ADDENDUM NO. 2

**Project: Project #: 403
Bus Electrification and Site Improvements**

ADDENDUM A

Revised DC fast Charger per owner direction, for BorgWagner model RES-DCVC 60-480, charger and 2 Dispensers. The following modify or supplement the original drawings:

**A1.21
ADDENDA A**

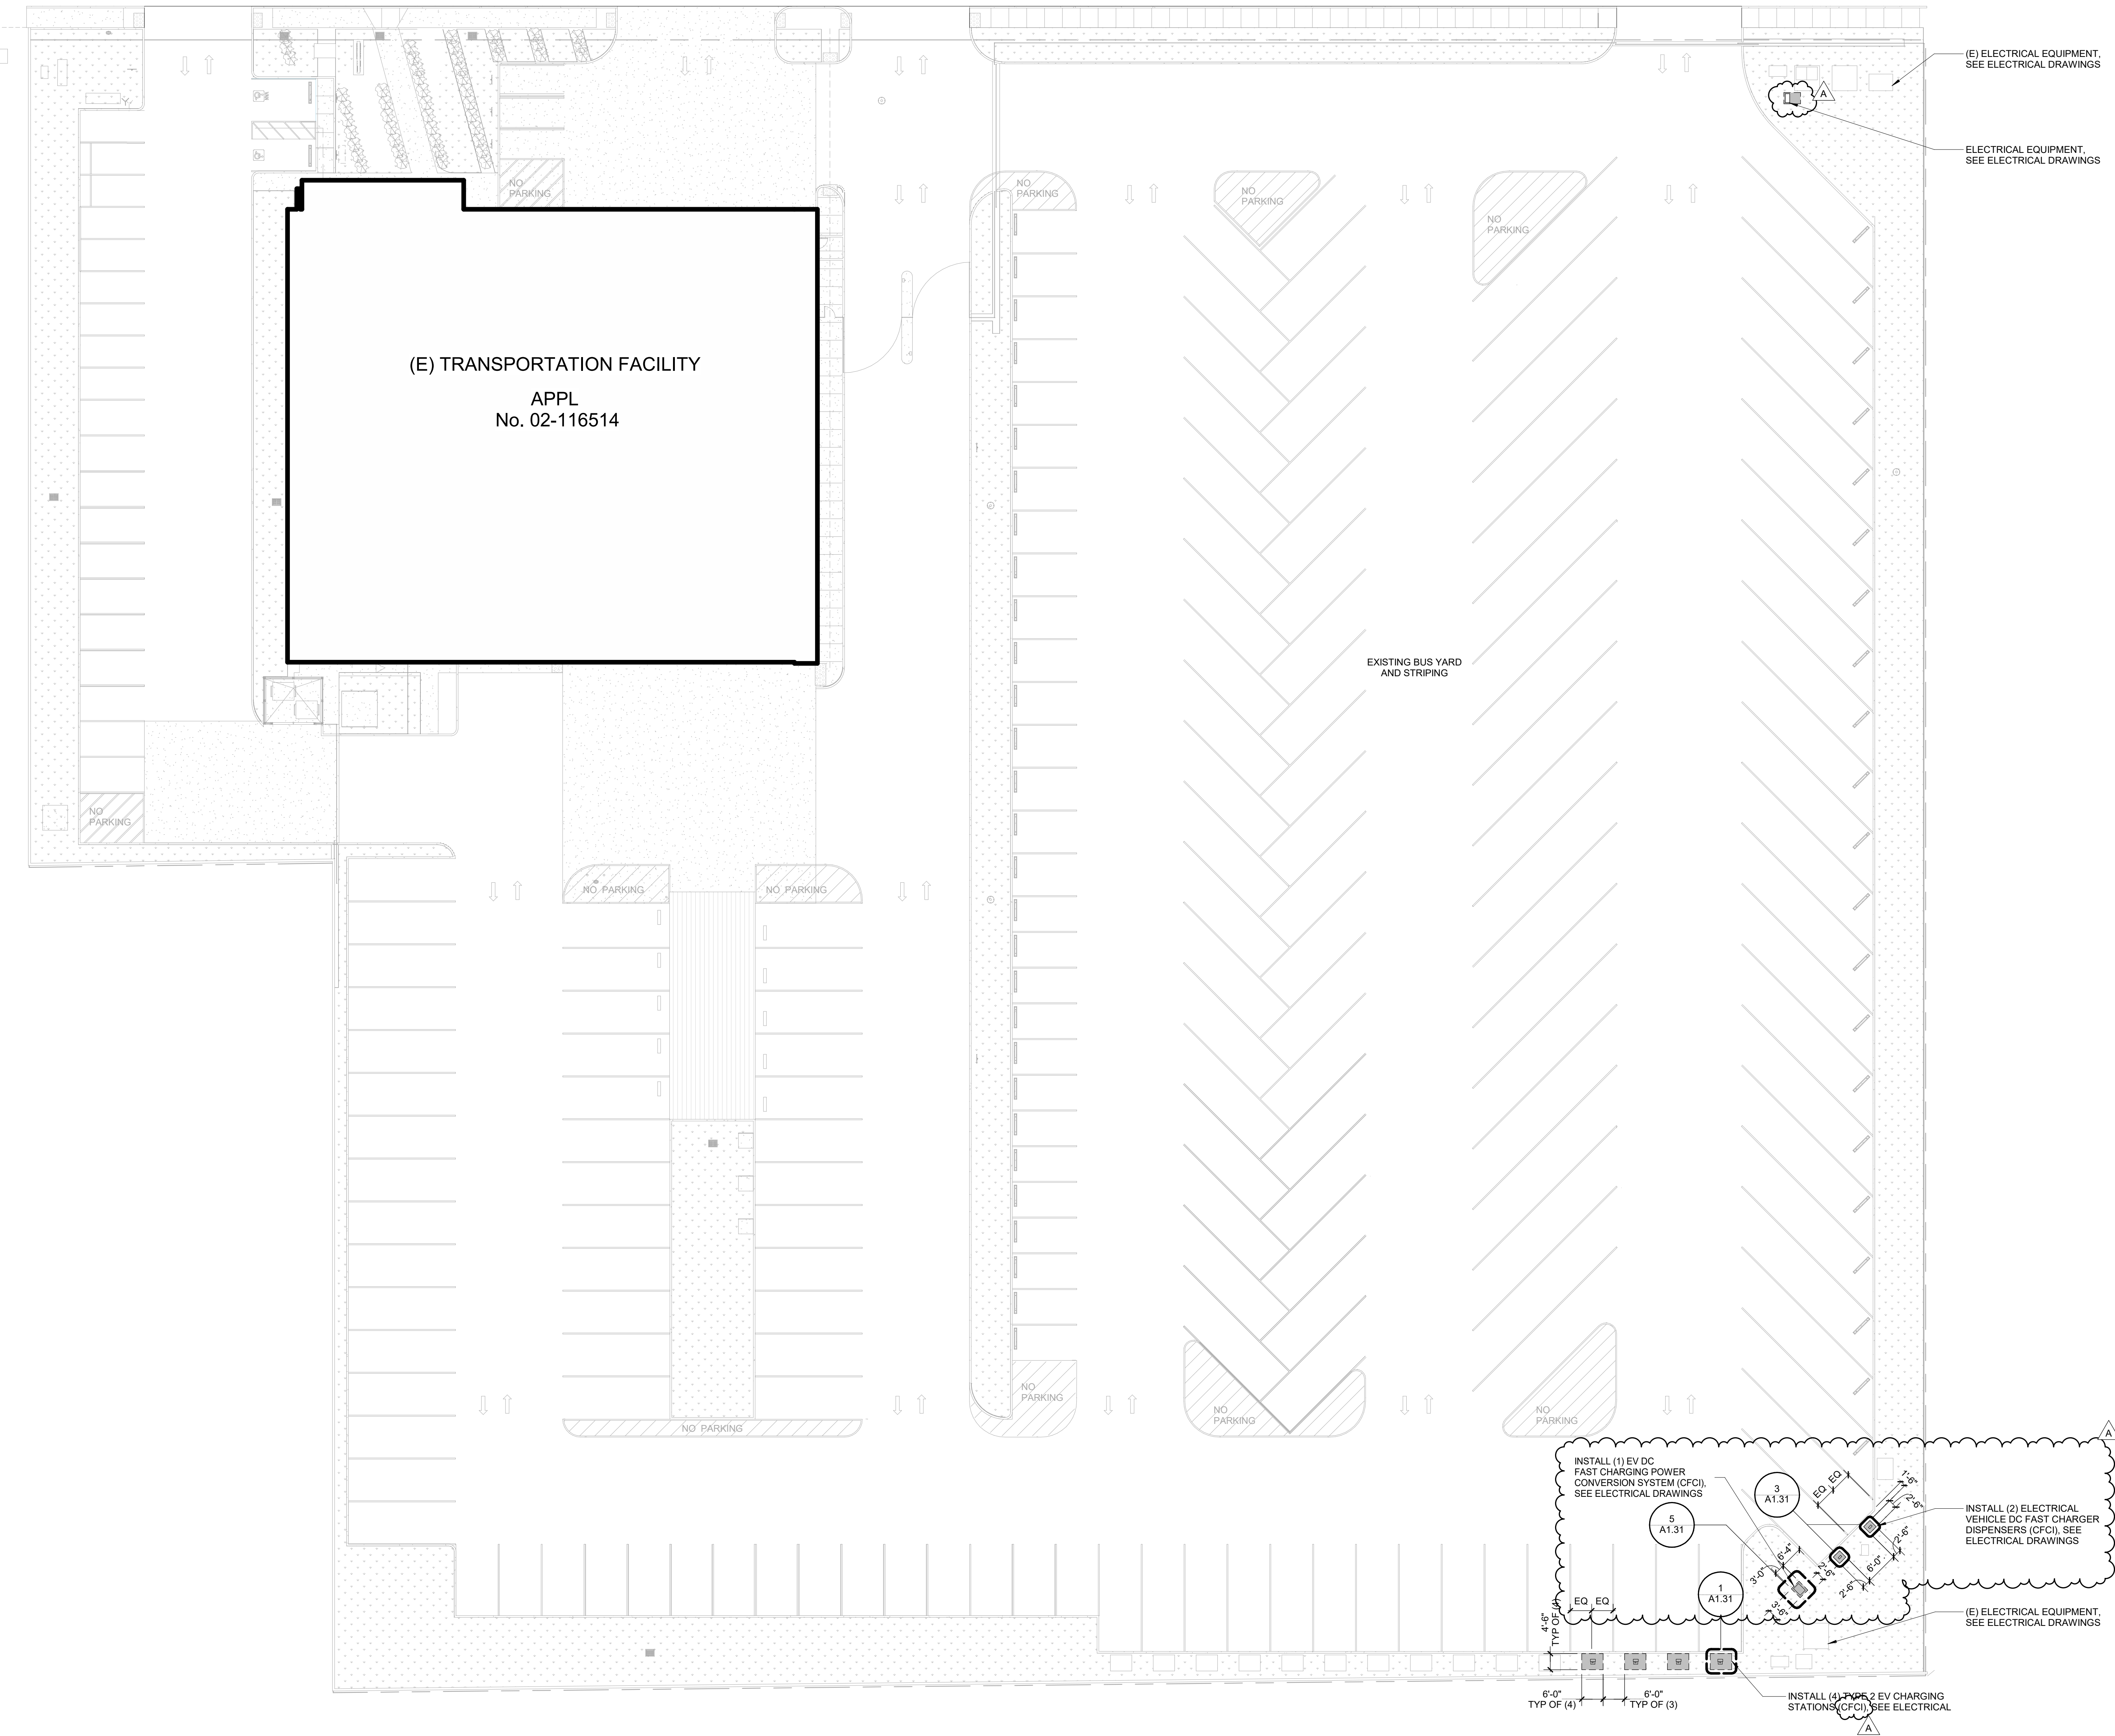
QUESTION #4: Key Note 3/E1.1 states that the contractor shall procure and install the EV chargers but sheet A1.21 has a note calling the chargers OFCI (owner furnished contractor installed) please advise.

RESPONSE: Contractor is to furnish and install all EV Charging units. (CFCI)

A1.31
ADDENDA A

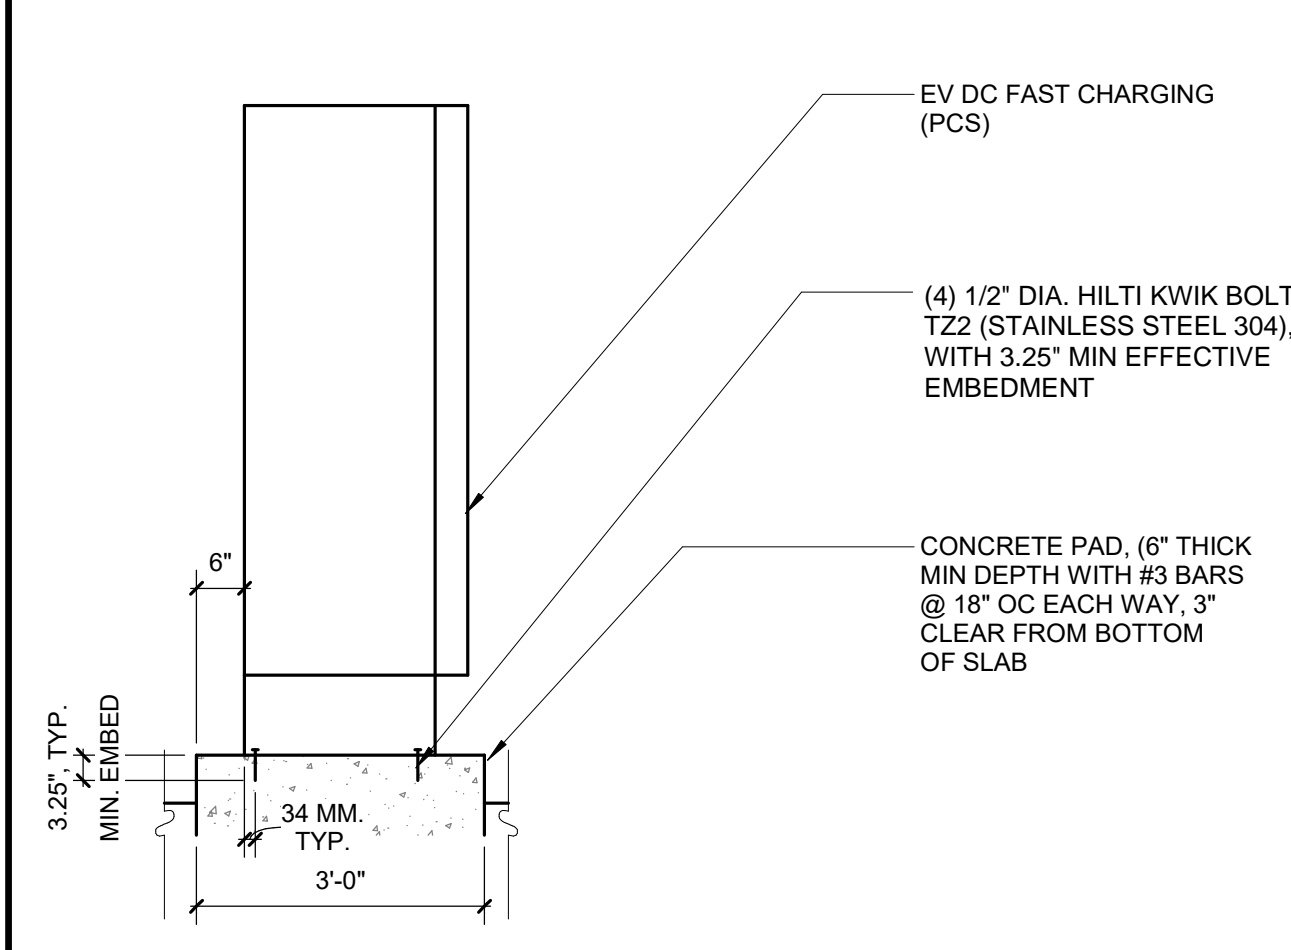
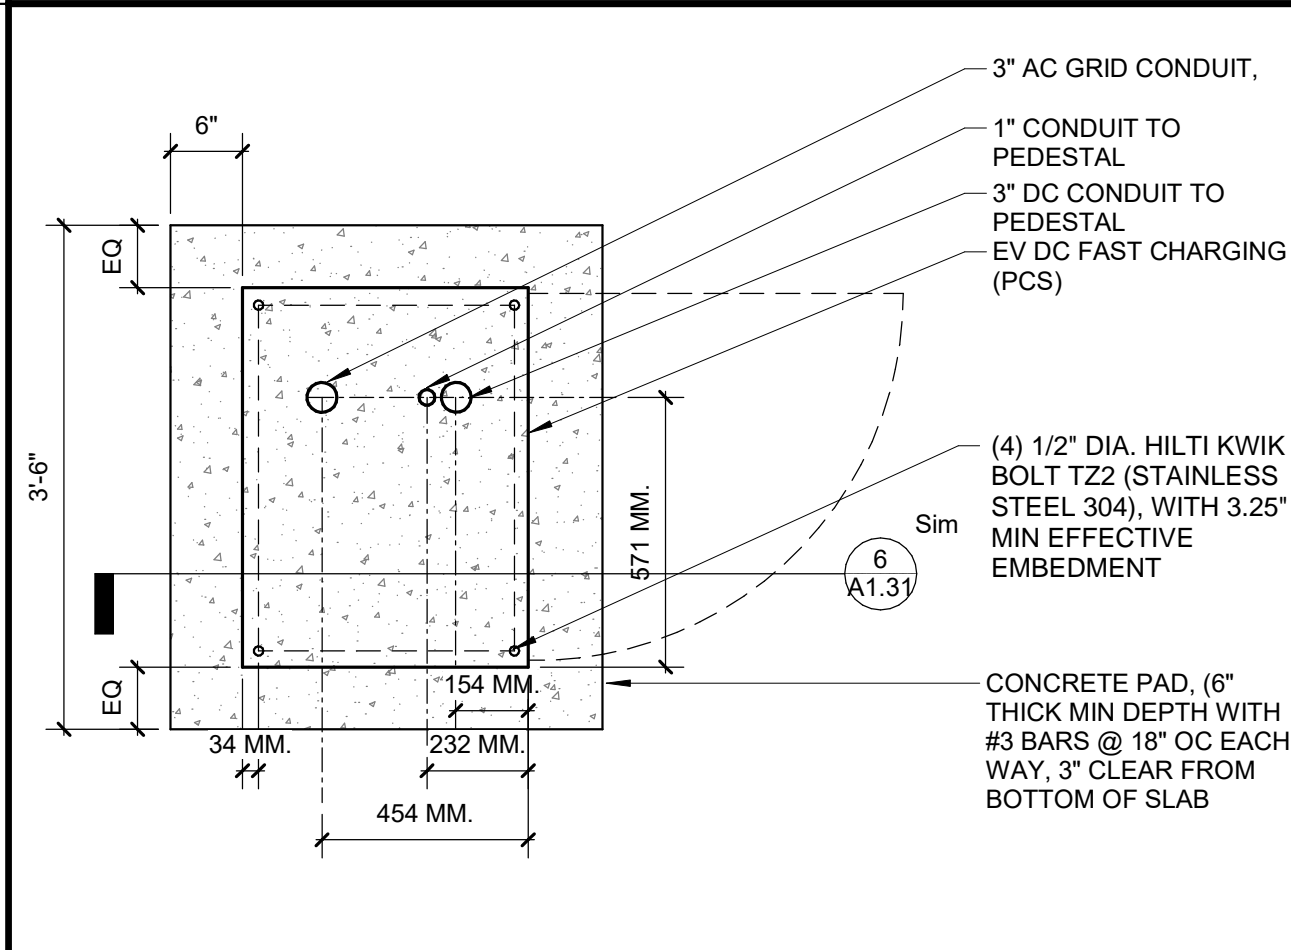
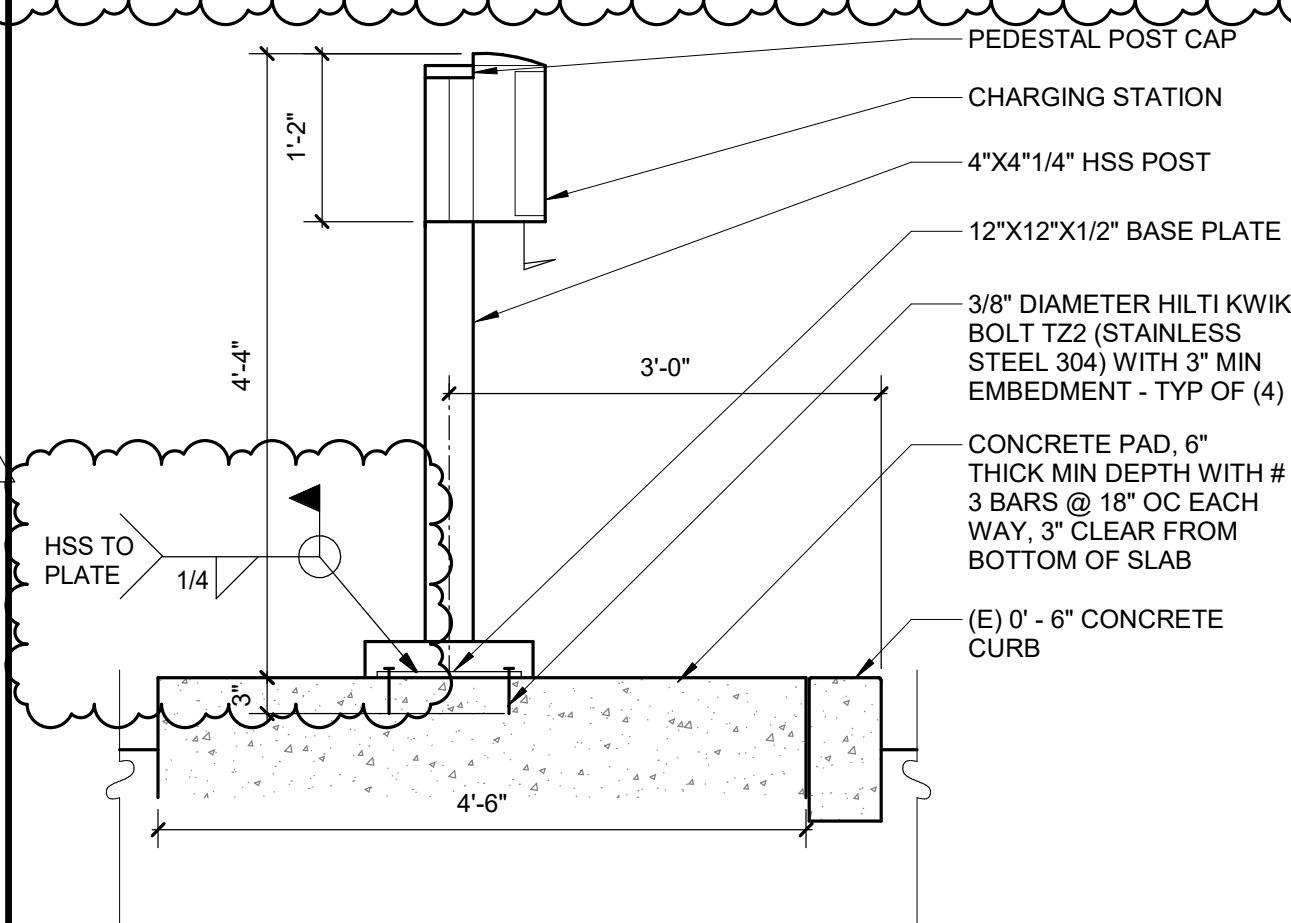
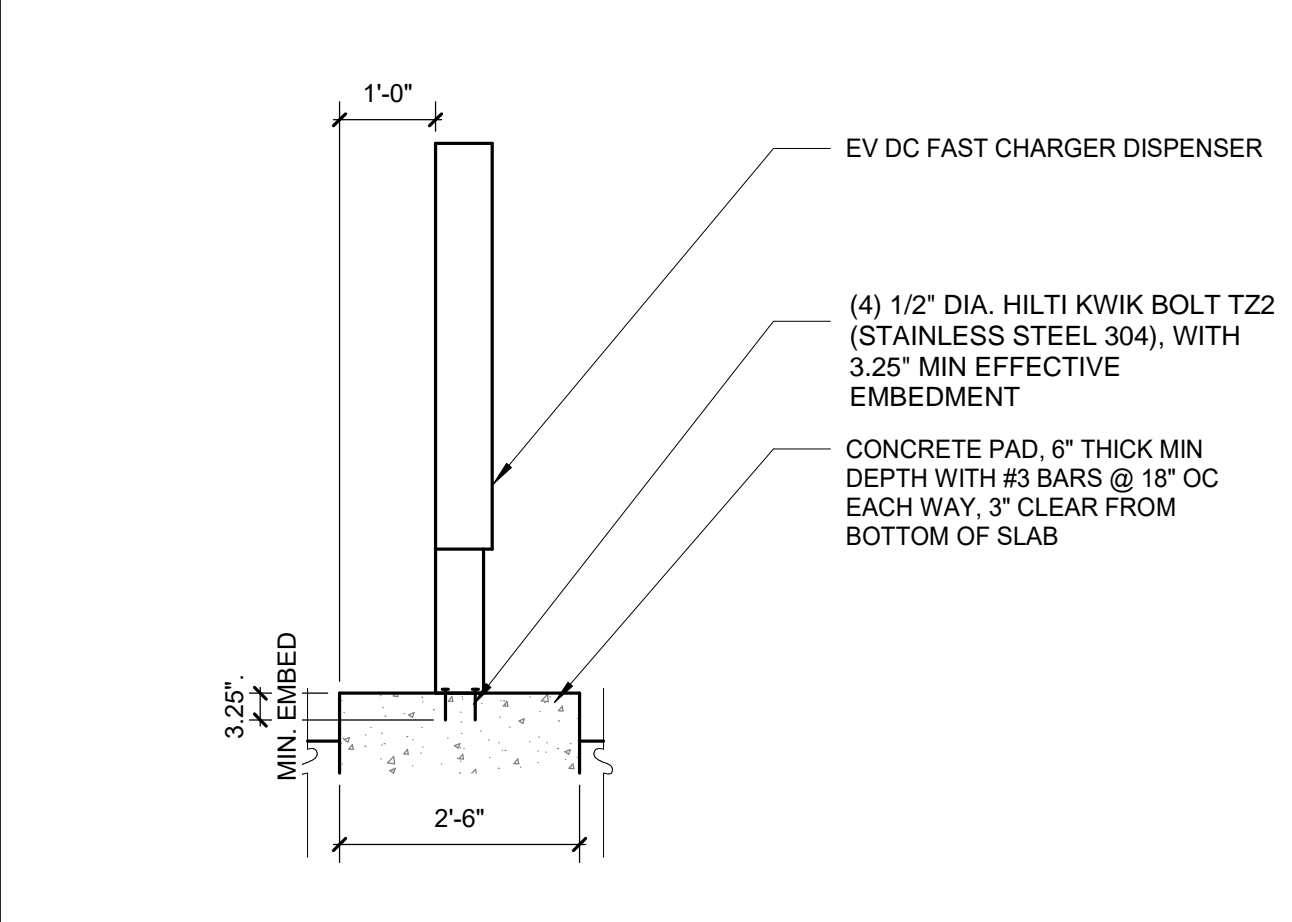
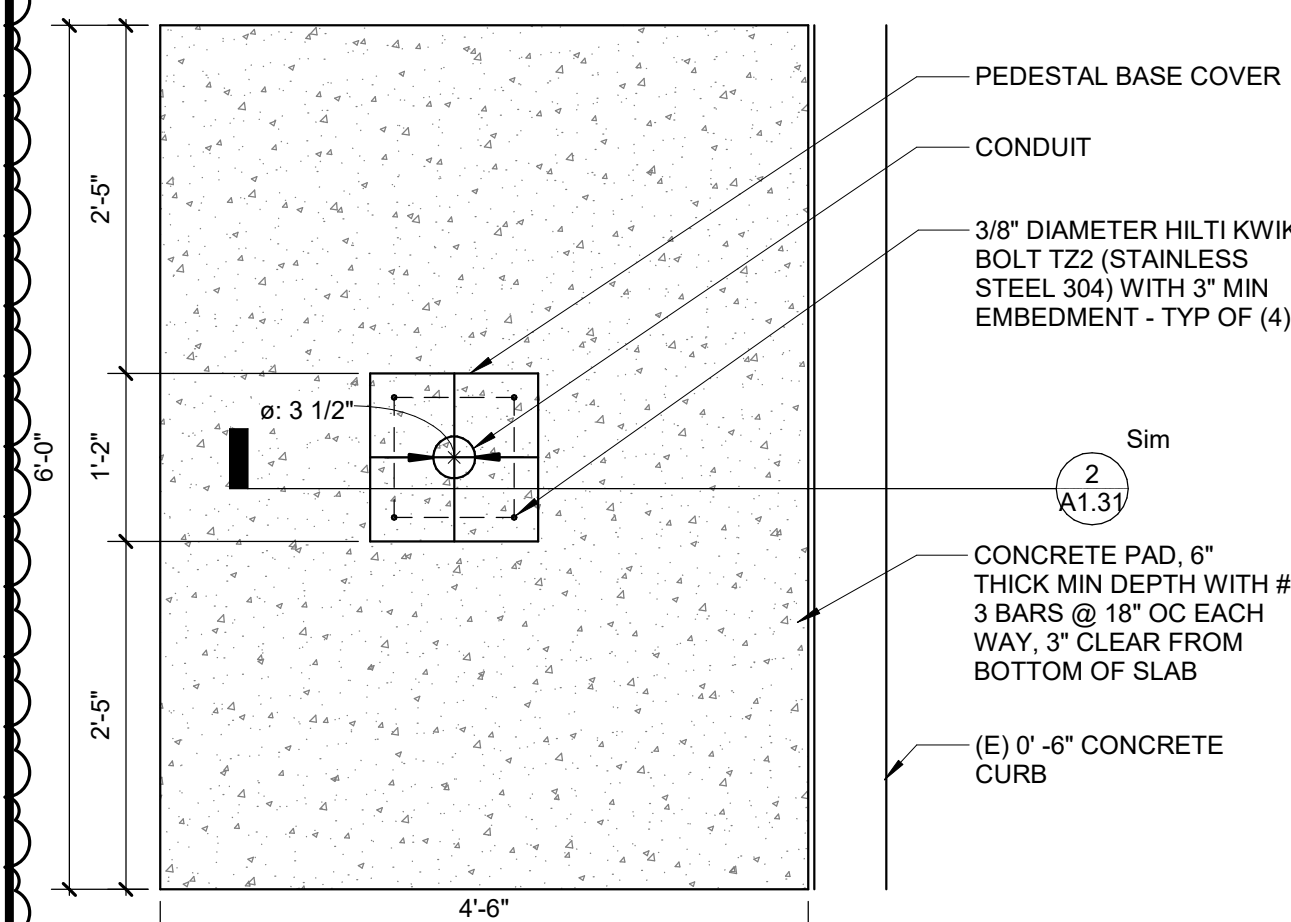
QUESTION #1: Is a contractors license A, N or B required if we (Brooke Electric, C-10) are able to self perform the concrete work, on a approved level, according to the plans specifications (sheet A1.31)?

RESPONSE: See AD1.01
